ICN Limit for 100GBASE-CR10

09/08/2011

- **Proposal is to change only the mated MCB/HCB ICN requirements to accommodate the 10 lane connector.**
 - No changes made to channel or cable assembly requirements

Crosstalk allocation

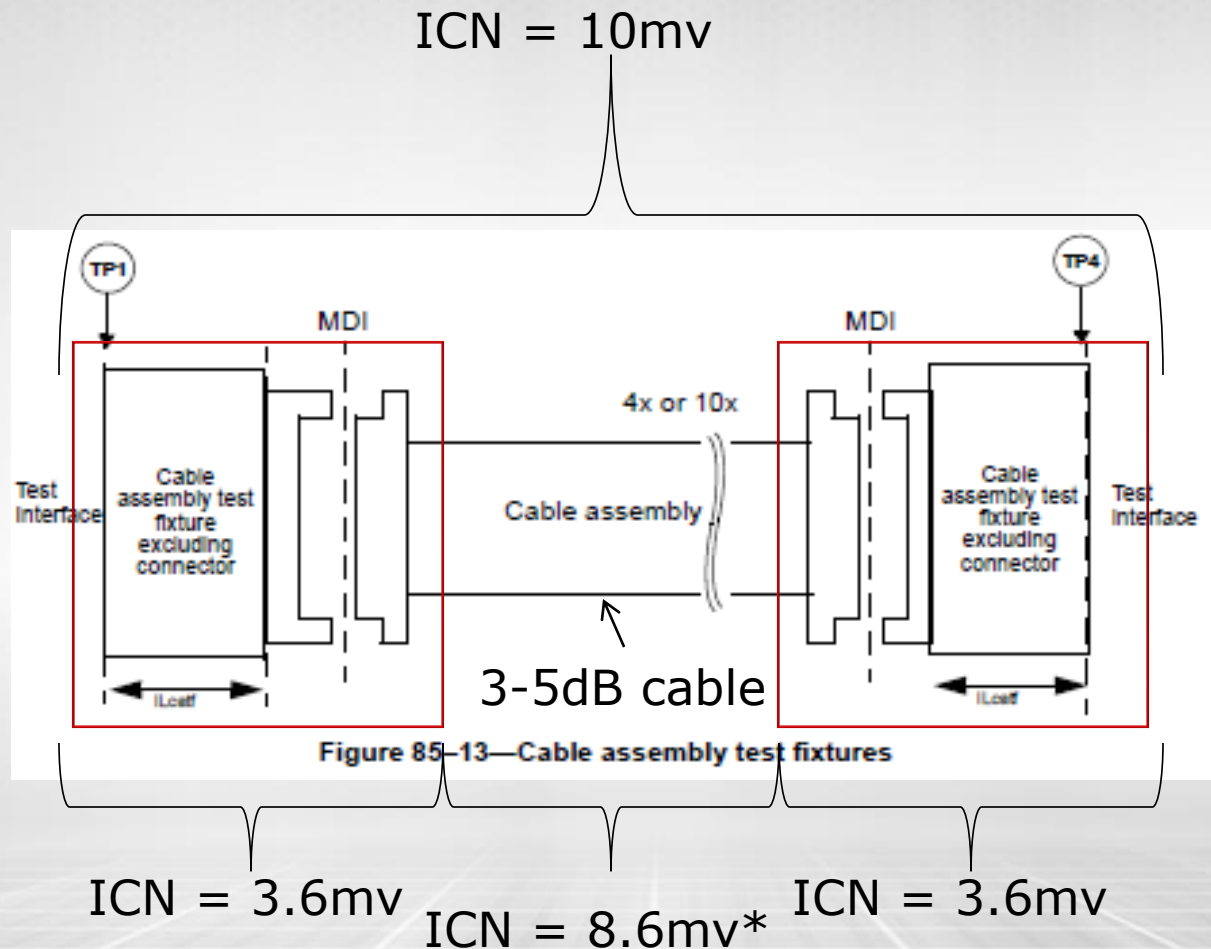
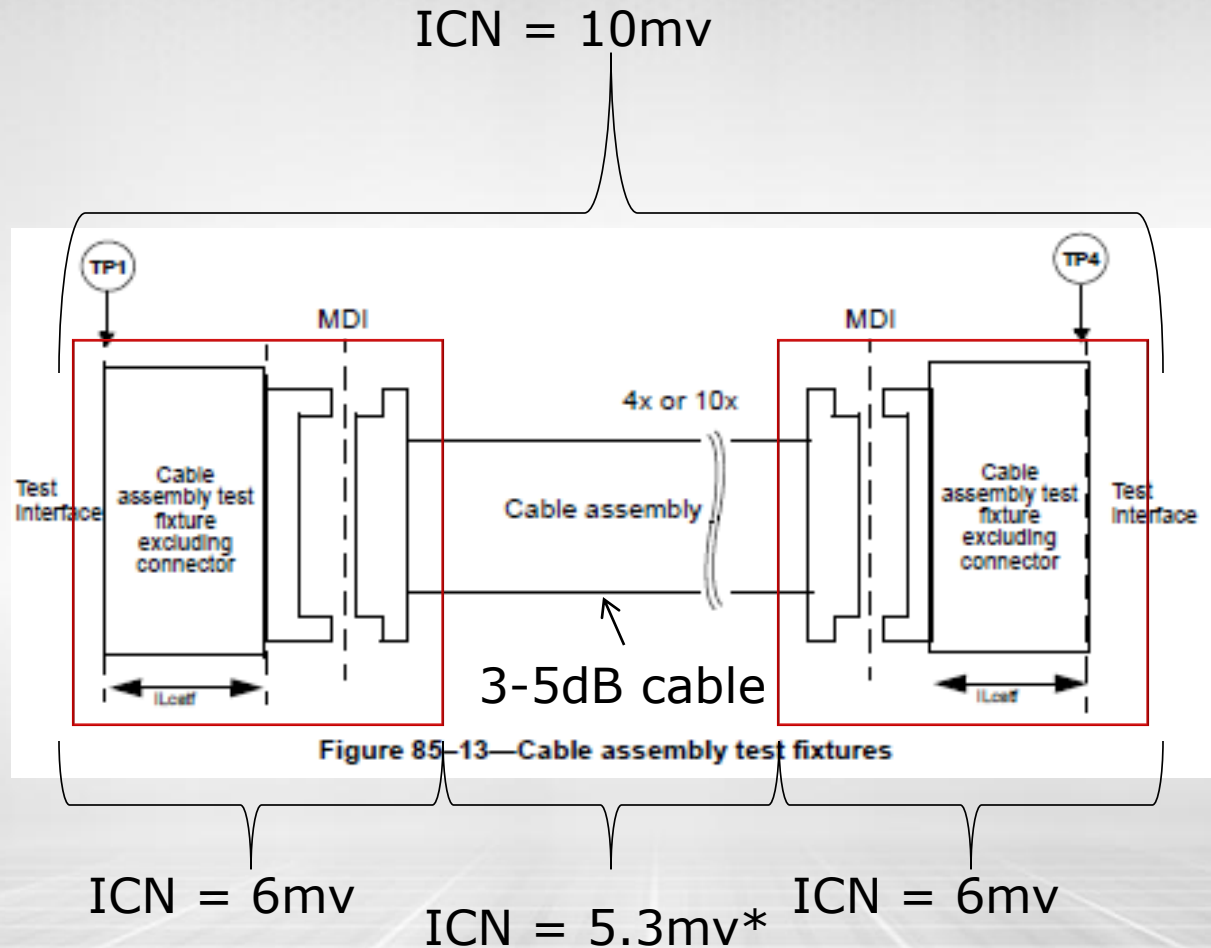
- We believe that the crosstalk/ICN was incorrectly divided between the connectors and the cables

Proposed Crosstalk allocation

Mated Test Fixture (HCB/MCB) ICN

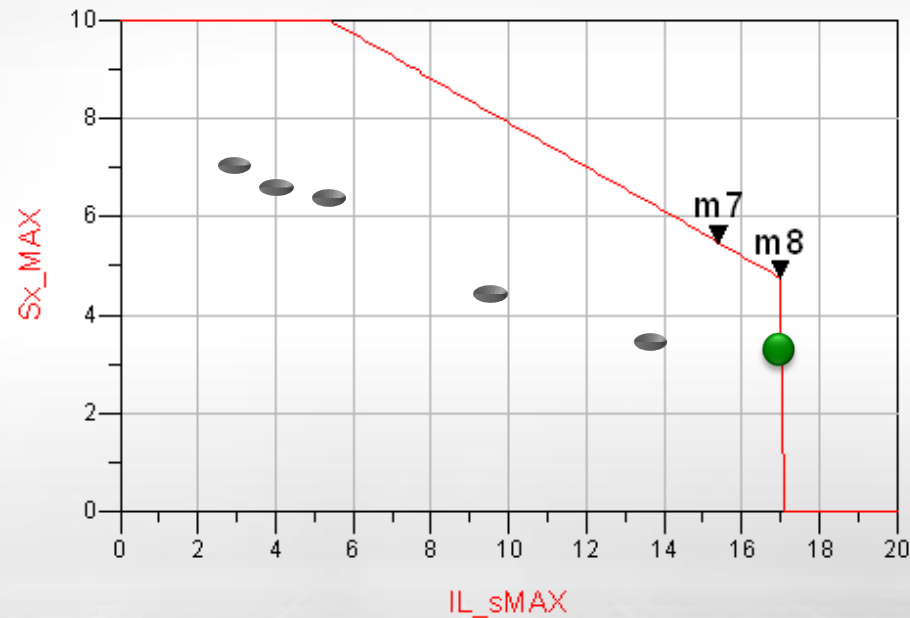
Simulated FEXT ICN (mV)	FEXT ICN Limit (mV)	Simulated NEXT ICN (mV)	NEXT ICN Limit (mV)	Simulated Total ICN (mV)	ICN Limit (mV)
Single Disturber	2.549	2.5	2.227	0.7	3.385	2.596
Multiple Disturbers	3.991	3.5	2.691	1.0	4.814	3.640

Simulated data matches measured data with adjustments for insertion loss

Parameters	Proposed ICN Limit (mV)	Current Std ICN Limit (mV)
SDNEXT ICN	3.0	0.7
SDFEXT ICN	4.0	2.5
ICN for Single Disturber	<u>5.0</u>	<u>2.596 (Calculated)</u>
MDNEXT ICN	3.5	1.0
MDFEXT ICN	5.0	3.5
ICN for Multiple Disturbers	<u>6.1</u>	<u>3.64 (calculated)</u>
